**SERVICE BULLETIN**  
**NO:06011-R3**

**MODELS :** TX-SR674 / TX-SR804 / DTR7.7

**SUBJECT :** Picture Interruption in output of 1080P signal via HDMI on Playstation 3

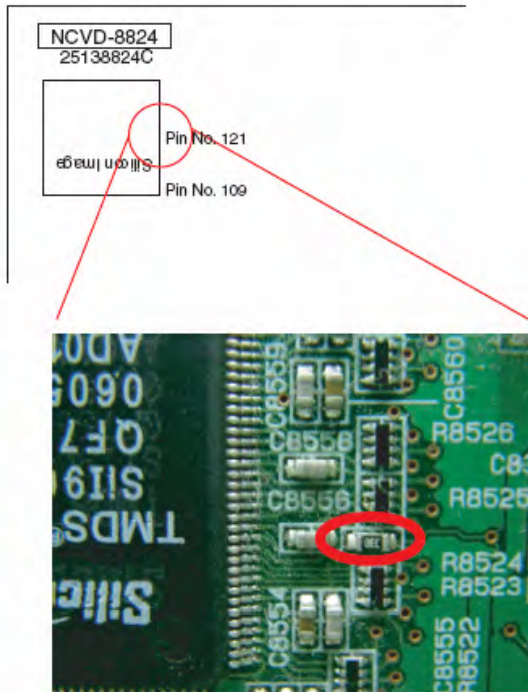
- 1) Remove Capacitor C8428 on HDMI Board NAVD-8824.
- 2) Change Resistor at R8524 from 33 ohm to 0ohm on HDMI Board NAVD-8824.

C8428 Remove this capacitor.

R8524 Change Resistance Value from 33ohm to 10ohm.

The resistance value of R8524 was changed to 22ohm first and then to 10ohm again. and finally to 0ohm . 0ohm is the best and 10ohm is better, but 10ohm and 22ohm are also effective. Therefore, when 22 or 10 ohm Resistor is mounted at R8524, it is not necessary to replace it by 0ohm Resistor as long as the unit has no problem.
